# SERVICE BULLETIN

No. 333

Piper Aircraft Corporation

Subject: Cabin Entrance Door Safety Strap Inspection and Replacement

### ● INSPECTION INSTRUCTIONS

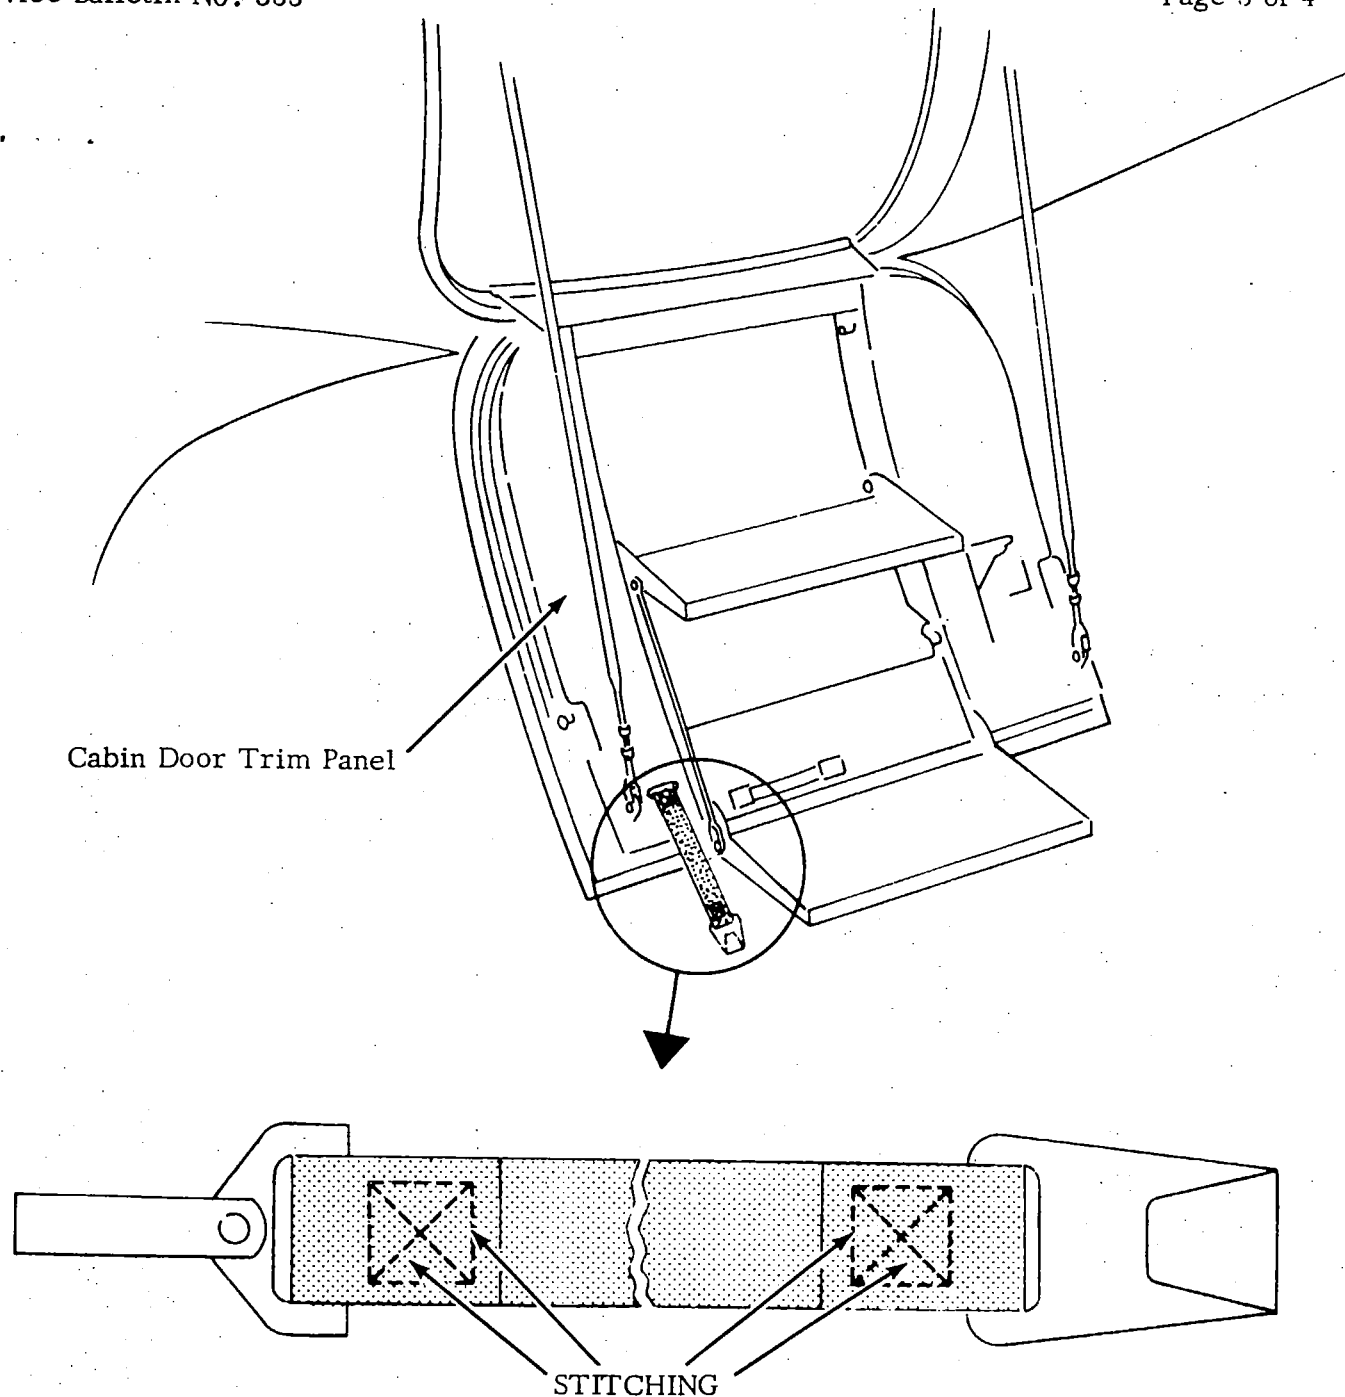
Inspect the stitching on both ends of the cabin entrance door safety strap to determine if the strap is properly stitched. If the strap is not stitched exactly as shown above, it must be replaced. Order one of the following cabin door trim panels which contain a properly sewn safety strap.

Part No.	Nomenclature	Aircraft Effectivity
43973-00	Cabin Door Trim Panel Assembly (Walnut Veneer)	Serial Nos. 31-552, 31-556, 31-558 to 31-654 inclusive
44319-02	Cabin Door Trim Panel Assembly (Beige)	Serial Nos. 31-655 and up
44319-03	Cabin Door Trim Panel Assembly (White)	Serial Nos. 31-655 and up
44319-04	Cabin Door Trim Panel Assembly (Blue)	Serial Nos. 31-655 and up
44319-05	Cabin Door Trim Panel Assembly (Gold)	Serial Nos. 31-655 and up
